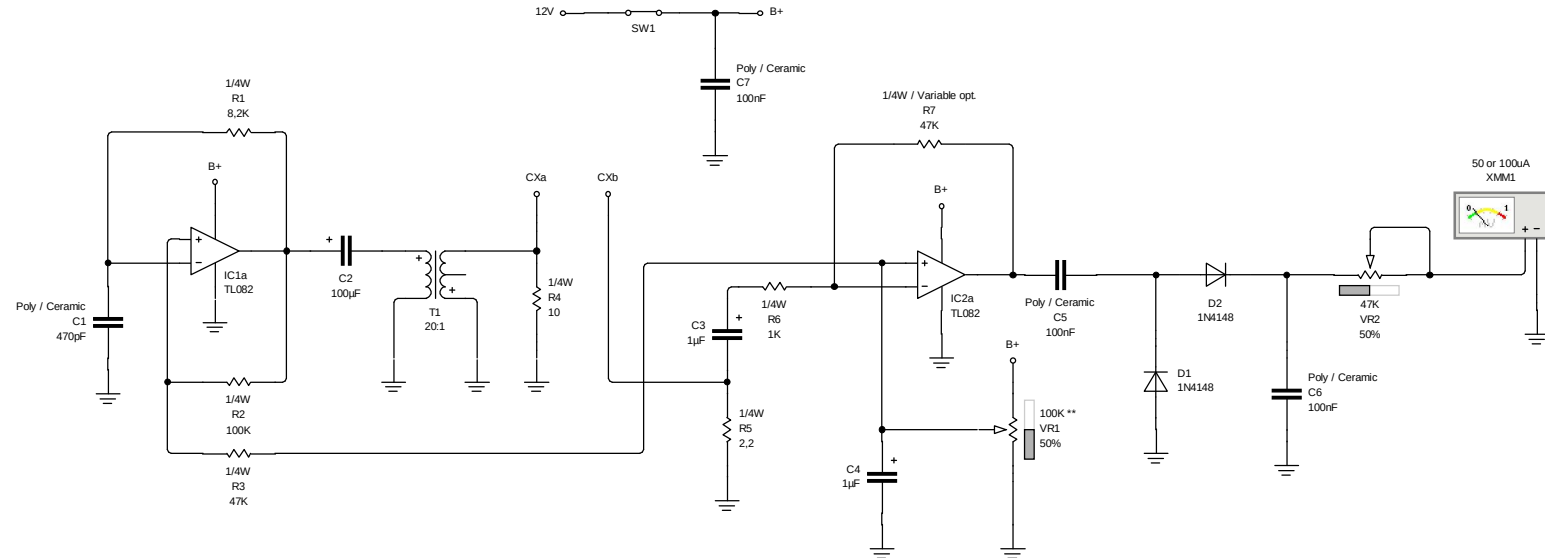
** Potential destruction of the potentiometer if you don't add a series resistor.
